**DATE:** 14 June 1999  
**REVISION:** A (12/14/99)  
**AIRCRAFT:** HUSKY A-1/A-1A/A-1B  
**SUBJECT:** Fluidyne C-2200 Retractable Ski Installation and Operation;  
A-1/A-1A Forward CG Expansion.

**Engineering aspects addressing Type Design changes are FAA Approved.**

**APPENDIX B**      Trim Cable Change - Husky A-1 Serial Numbers 1329 and Earlier

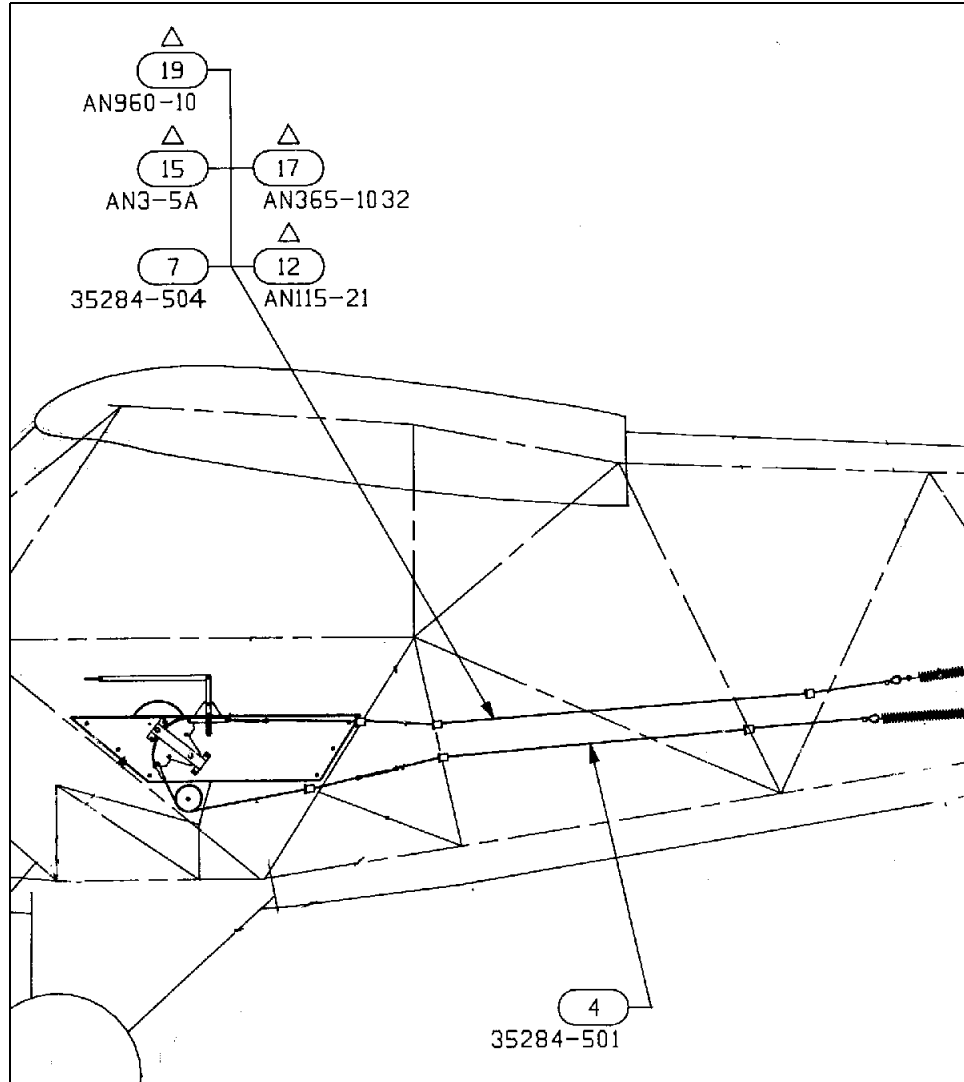
1. Replace upper and lower trim cables with new 32584-501 and 32584-504 cable assemblies as shown in the figure below.

2. Check elevator trim as follows:
  - A. Adjust the elevator trim control to the full nose down (elevator trailing edge down) position.
  - B. At full nose down trim position the top cable tension should be 55 to 65 pounds and the bottom cable should be 65 to 75 pounds.
  - C. Check the force necessary to move the elevator at an arm of 26 3/4 inches aft of the hinge center line. With the full nose down trim, force required to pull the elevators up to neutral is 12 3/4 pounds to 17 3/4 pounds. The force required to pull the elevators down from full nose up trim to neutral is 1 1/2 pounds to 6 1/2 pounds.
  - D. Should the forces fall outside the ranges above, check the control system for wear, binding, frayed cables, worn fairleads and control wheel and pulley misalignment.
  - E. Following rigging the elevators should move freely throughout the full range of travel.

**APPENDIX C**      Husky A-1A Weight and Balance Envelope

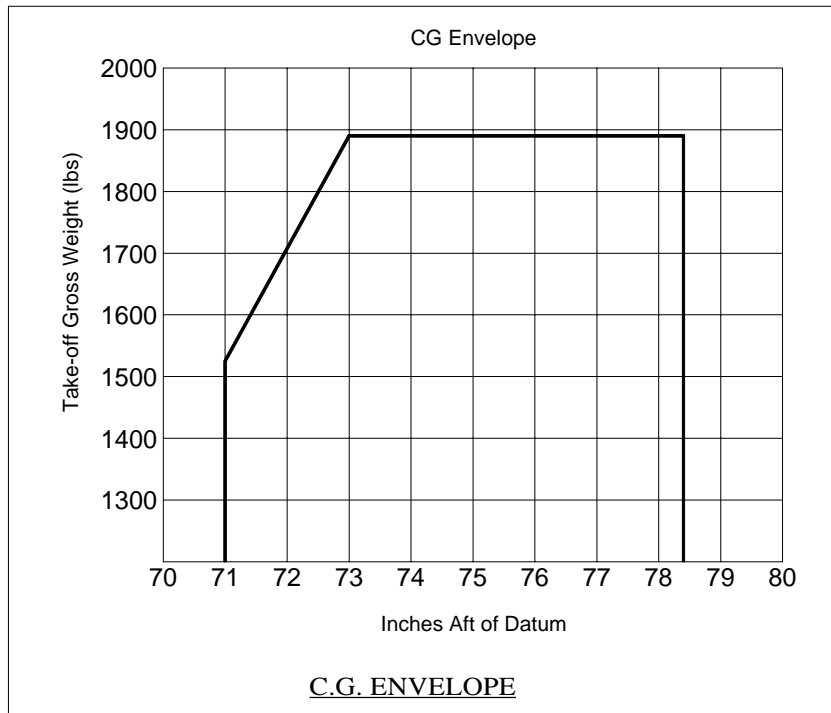
1. Change Section I - OPERATING LIMITATIONS, Subsection C - WEIGHTS to read:

2. The CG Envelope diagram in Section V - LOADING INFORMATION, Subsection A - WEIGHT & BALANCE, 5. - DETERMINING AIRPLANE WEIGHT & C.G. is replaced with the following diagram:

<u>Weight and Center of Gravity Limits (Normal Category)</u>	
Most Forward Limit.....	FS 71 at 1525 LBS
Most forward Limit at maximum Gross Weight.....	FS 73 at 1890 LBS
Most rearward at Maximum Gross Weight or Less.....	FS 78.4 at 1890 LBS
